Access Compliance Report

Public Rights-of-Way

(Curb Ramps)

Intersection ID: 5563	Main Street: N I-77 EXIT 16 RA	Cross Street: REAMES_RD	Location: SE
ADA ID: 26510B1DBAB1	Ramp Type: Directional1	Initial Pass/Fail: Pass	Overall Compliance: No
Codes/Mitigation Info/Possible Solution		Field Measurements/Component Compliance	
Severity Score: 0.25

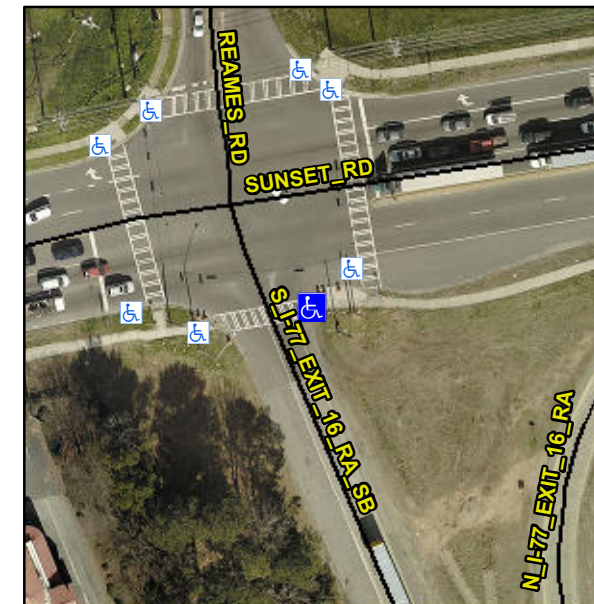
NO CURB

R304.5.3, R304.2.2-Perp, R304.3.2-Para

**Remove & Replace Entire Ramp.
Remove & Replace Gutter.**
